**AN/SRC-10(), -11(), -12(), -13(), -14(), -15()
REMOVAL OF AUDIO RECEPTACLE WATERPROOF
CAPS**

AN/SRC-10Y-15Y: 1

Figure 2. Method of Marking Trimmer Capacitor Positions Before Tuning (754)

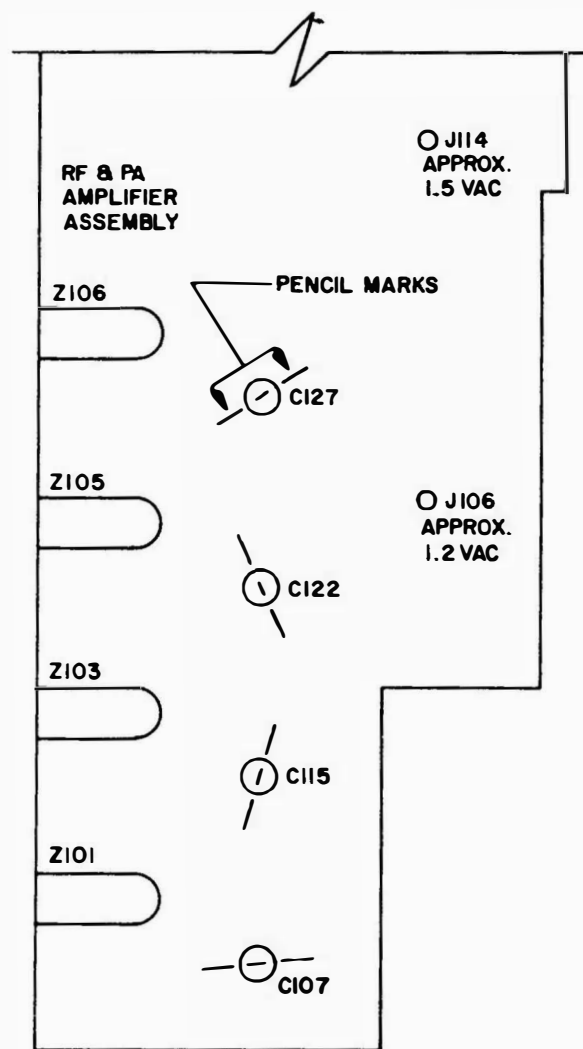
- a. Align the RF and PA assembly at 399.9 MHz in the transmit condition.
- b. Pencil mark the position of the trimmer capacitors (see C127 in figure 2).
- c. Decrease the frequency by 10 MHz
- d. Tune the trimmer capacitors and note the direction of rotation versus the up/down direction of PAig on the front panel meter.
- e. Return the trimmer capacitors to the pencil marks.
- f. Bend the tabs of Z101, etc., indicated as follows, based on results of foregoing step d.

FIGURE 1
MODIFICATION TO PIVOT PLATE & LUG OF UPPER DRAWER OF AN/SRD-7 RECEIVER

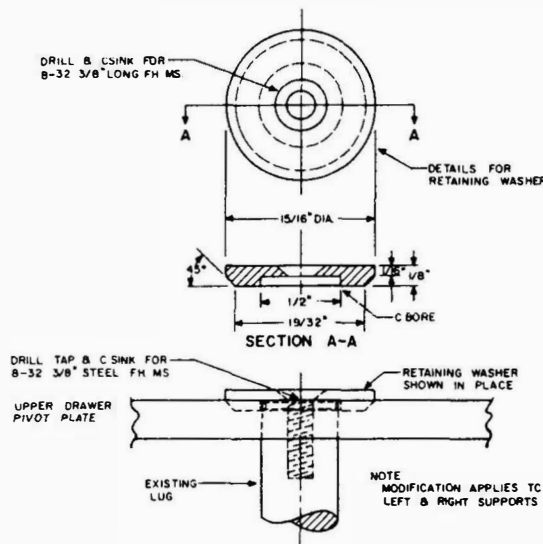
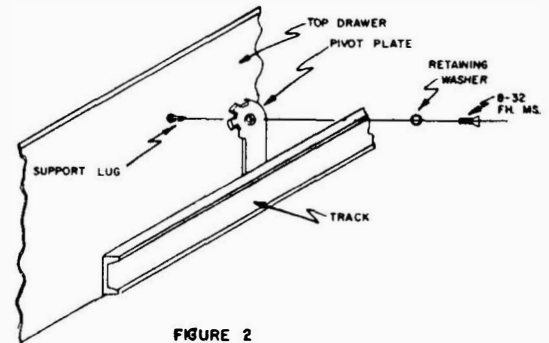
To prevent the upper drawer of R-623/SRD17 from slipping from its pivot plate when the drawer is extended, the following modification is recommended. Drill, tap, and counter sink support lug as shown in figure 1. Assemble unit as shown in figure 2.

Figure 1. AN/SRN-15 Protective Cover - Front and Side.

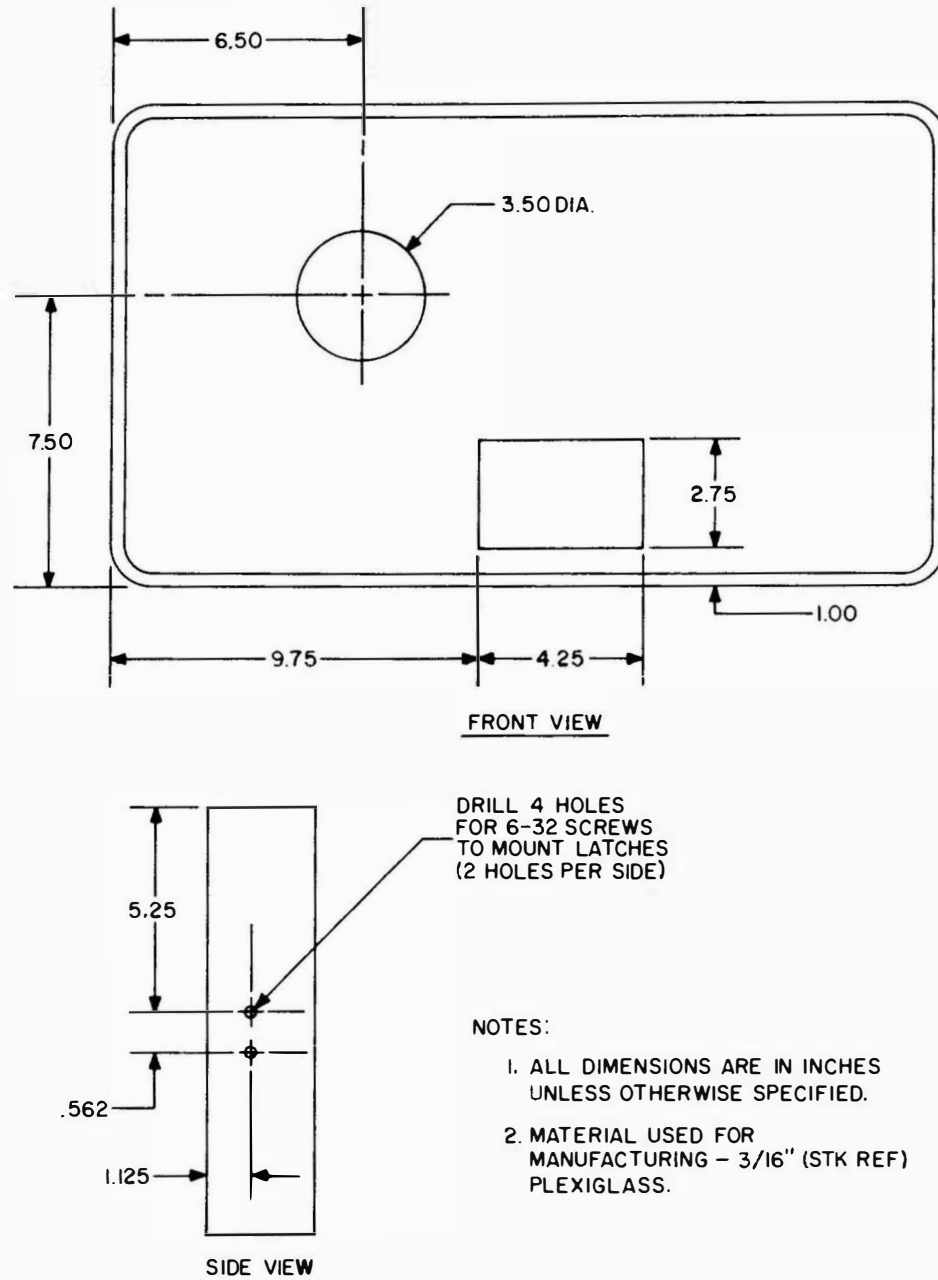
Construction details are shown in figures 1 and 2. The cover is attached to the RT-1084/SRN-15 using suitcase catches similar to those used to secure covers on portable test equipment. Two holes are drilled in the front of the cover to provide access to the

FIGURE 1 TO K-3004-4L
BASE BLOWERS

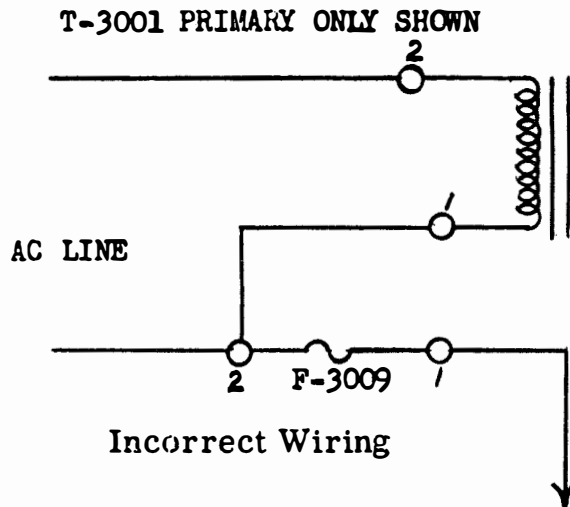
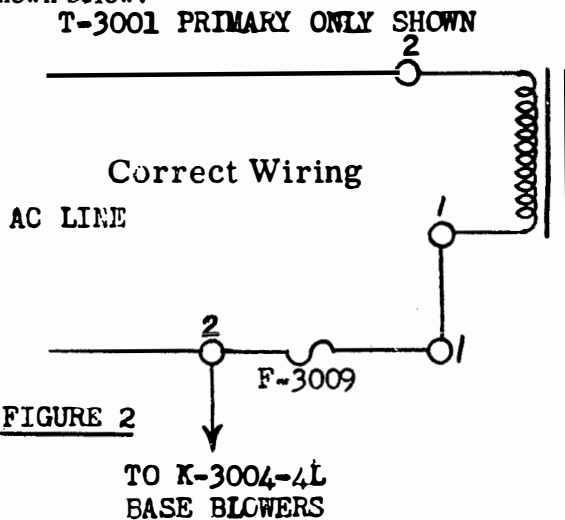
1. Relay K-3004-4L was wired to terminal 1 of fuse F-3009, instead of terminal 2 of F-3009.
2. Transformer T-3001 terminal 1 was wired to terminal 2 of fuse F-3009, instead of terminal 1 of F-3009, Figure 1.

The correct wiring, (Figure 2), is shown in the schematic diagram, figure 7-50 of Instruction Book NavShips 92121, for AN/SRT-14, -15, and -16.

The correct wiring, as shown in the schematic diagram, figure 7-50 of Instruction Book NavShips 92121, for AN/SRT-14, -15 and -16 is shown below.

Figure 1. Typical AN/SSR-1 Module Connector

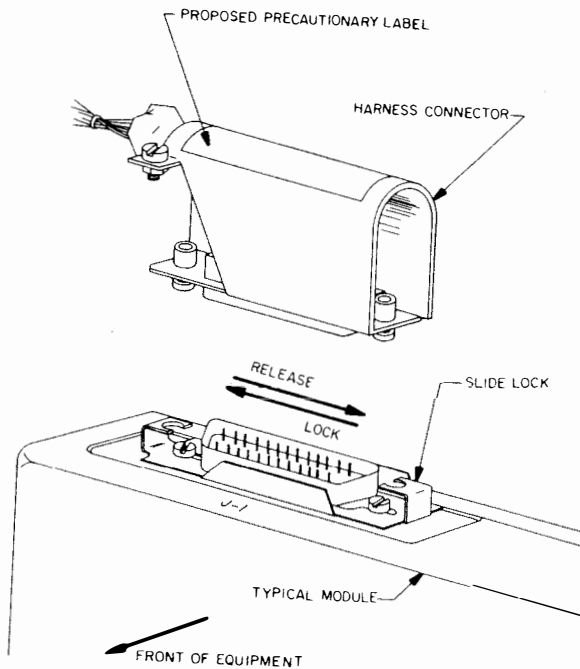
As an added reminder, precautionary labels are being manufactured for automatic distribution to the Fleet. A label will be provided for each of the nine wiring harness connectors in the units and shall be affixed as shown in figure 1. (EIB 919)

Figure 1. NTDS GAIN Control Knob, Modification

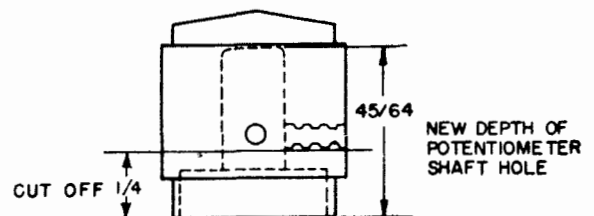
1. Remove NTDS GAIN control knob from potentiometer-shaft.
2. Using a lathe with a 1/4-inch counterbore drill, increase depth of potentiometer shaft hole to 45/64 inches (figure 1). Wrap a piece of tape around drill in a position to prevent drill from counterboring beyond 45/64 inch dimension.
3. Using a cutting tool in the lathe, cut 1/4 inch off bottom of knob and remove any rough edges with a file (figure 1).
4. Place control knob on potentiometer shaft and tighten two allen-head screws.

Figure 1. Handset Cable Wiring Change

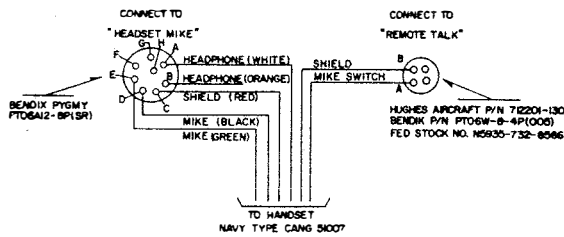
Handsets, Navy Type CANG 51007, can be modified for use with intercommunication station LS-468/S. Remove the connector from the end of the handset cable and install two connectors to the split cable end as shown in figure 1. The connector, 712201-180, is the same as that used on the NTDS console footwitches; the Bendix pygmy connector is the same as that used on the NTDS intercom headsets. (Note: Since handsets are made by several manufacturers, the color coding may vary. It may be necessary to verify connections at the handset.)

Figure 1. Switchguard (HAC P/N 581664) Modification

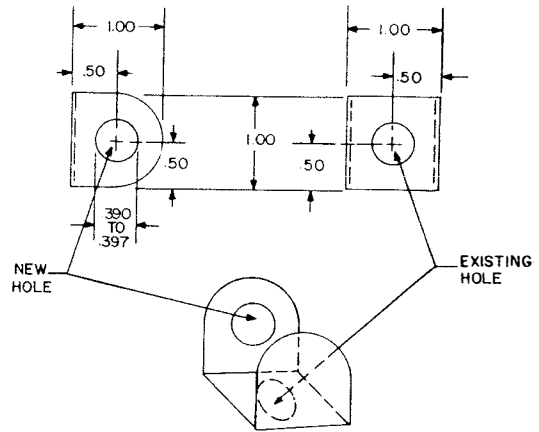
The presently installed switch guards (HAC P/N 581664) may be removed, a hole placed in the end (see Fig. 1) and reinstalled with the switch toggle through the new hole. (685)
